Haskoning UK Ltd.
Water & Maritime

Subject: Milford Haven Port Authority Jetty Improvements (Application Number: CML2484): Further Information Request Response

Figure 1 Sensitive Habitat Zones as outlined by the Recreational Users Voluntary Agreement for the Pembrokeshire Marine SAC, 2014³

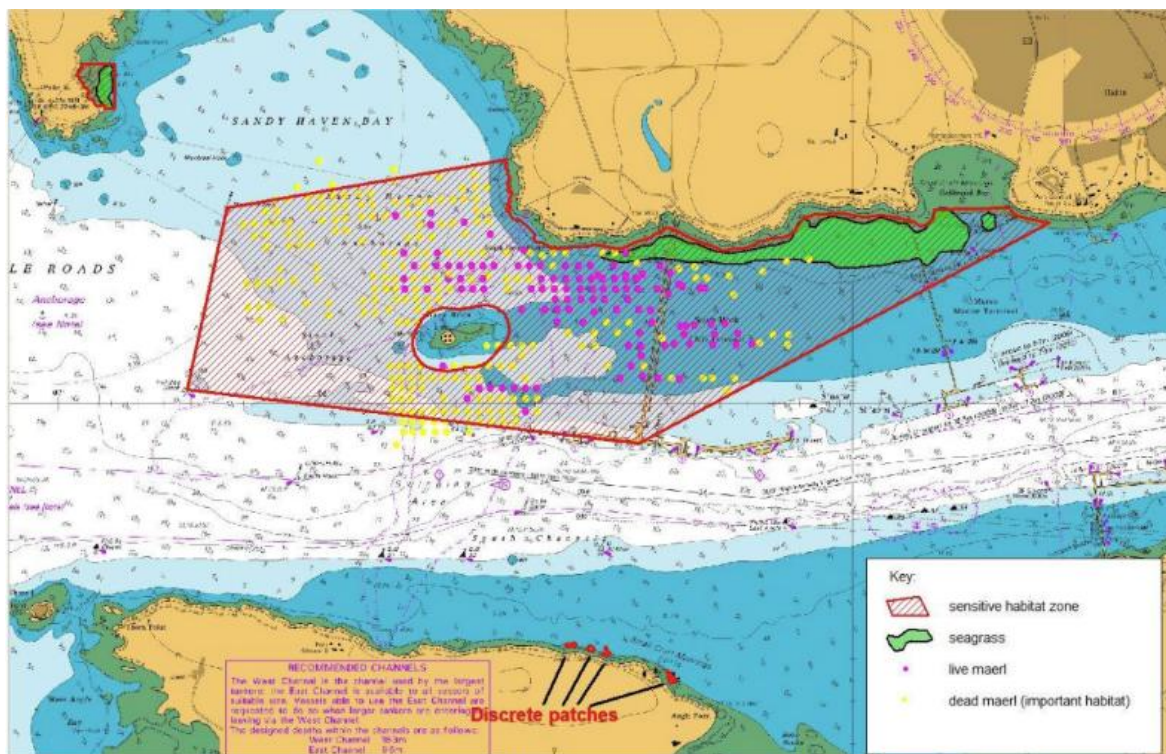
We advise that a limited amount of drop-down video (DDV) transects directly under the footprint of the proposed works (including a suitable buffer zone) to discount the presence of potentially sensitive habitats e.g. maerl, seagrass beds.

As part of our previous response, it was noted that the boundary of the sensitive habitat zone for seagrass and maerl, as outlined by the Recreational Users Voluntary Agreement for the Pembrokeshire Marine SAC¹, is located 300m west of the jetty. **Figure 1** below, from the Voluntary Agreement, shows no overlap of the sensitive habitat zones with the proposed works. From the data available on DataMapWales, the closest maerl habitat is located 1.1km from the proposed. Therefore, for maerl, our position remains that there is no potential for direct impacts such as loss or damage.
